Supplementary Evidence on Transport Infrastructure, relating to the new LTP

Cardiff's 15-year Local Transport Plan was adopted by the Cabinet in Nov. 2014. How does it face up to the transport issues and match up to the LDP? Cardiff's transport strategy since 2000, in the era of 'sustainable transport'-speak has been a failure. Fine words, but in practice going backwards. Just rephrasing the fine words in the new document shows continuing refusal to assess the reasons for failure and lack of seriousness in the policy.

Figure 3 Example of potential stations based development at Ely Mill

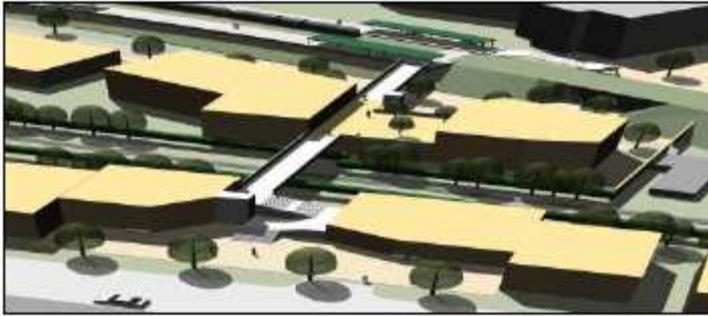
The Council is not giving due priority to the metro scheme. They had the chance to secure a station at Ely Mill on land owned by the developers and using s.106 funds. The picture below is included in the latest Metro study. But they approved changed plans in 2014 with no station and diverting S.106 funds to roads (officers' insistence on £5M for full access onto the A48). They have no plan to integrate the metro-tram into the 'integrated transport hub' on Central Square. High-quality provision needs space there (or rising from just under the Square). A speedy tram-train system includes some slower road-running, but still takes space for platforms and interchanges as eg. the Manchester Metro-link (images in Annex 2). However, Cardiff Council have not required space for it in the developer-generated master-plan driven by the BBC office development. From Press reports, this includes the Metro simply on-street in lower St Mary's Street and Wood Street among the many traffic uses and subject to disruption by Millennium Stadium 'events'. They've paid no regard to the space demands of a system like Manchester Metro-link. In partnership with Rightacres as developer, they've avoided discussion of the AECOM scoping report and deferred the planning application from October till days pre-Christmas. The application was not posted on the website and the Council will not make public their planning proposals for the Metro until Easter 2015. Rather than produce proposals in time for the LDP Inquiry, their timing appears chosen to avoid it.

New *Interchanges/Bus Hubs* (3.1.11) were supposed to include one near Ely roundabout over the rail lines (by the new Ely Mill station is an obvious choice) but the LTP allocates no site or funds, just claims 'ongoing discussion'. In contrast it allocates £1.4M for a bus-link across the Cardiff Barrage, which is more problematic and also subject to discussions (and the VoG's LDP inquiry).

A469 (Caerphilly Road) - Transport And Accessibility Improvements October 2014

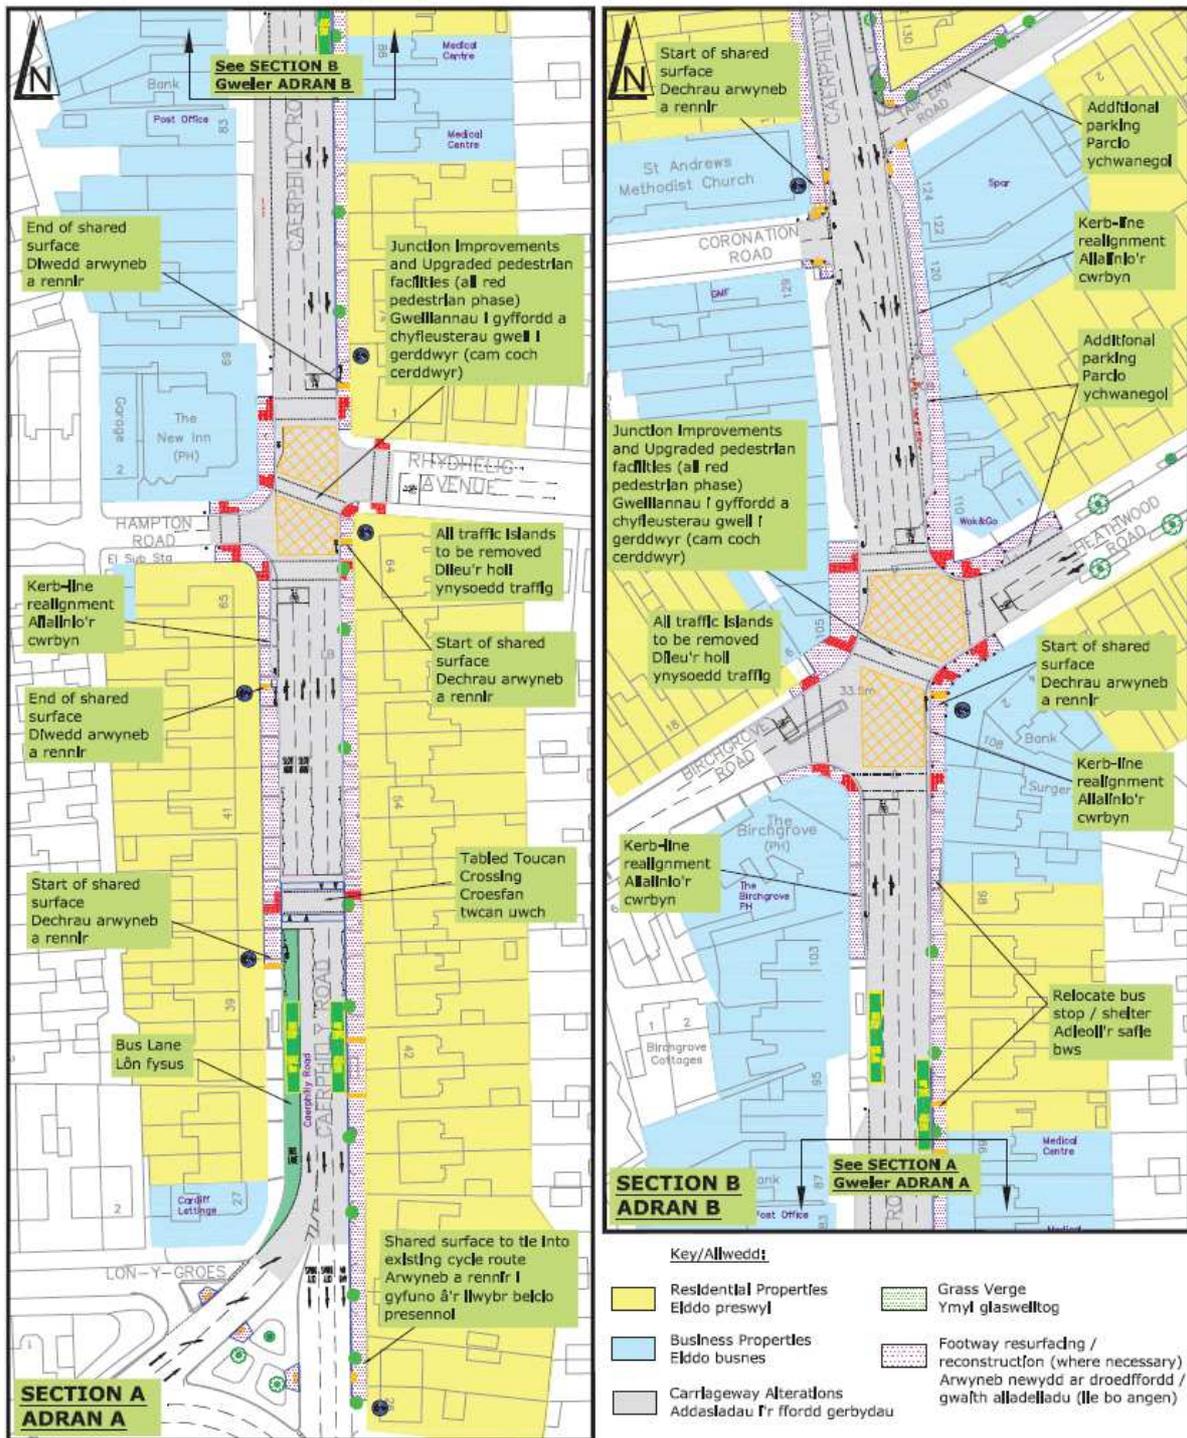
This scheme is supposed to provide for pedestrian and cycle access to the shopping area on a busy through road. Instead of traffic calming and giving space to pedestrians and cyclists, they ignore the Active Travel Guidance and set out to put cyclists onto the pavements, by re-designating them as 'shared space'. They claim to improve safety, but do not consider the safety of pedestrians or the hazards to cyclists of jumping on and off pavements, and do nothing for safety of commuting cyclists on the roadway.

To provide for cycling on the Caerphilly Road, the AT design guidance (6.13) prescribes: *Full consideration should be given to options for the suitable provision for cyclists on the carriageway or in a separate space for cycling – either through motor traffic speed / volume reduction, junction treatment and reallocation of carriageway space – before considering taking space away from pedestrians to create cycle tracks or shared use paths.*
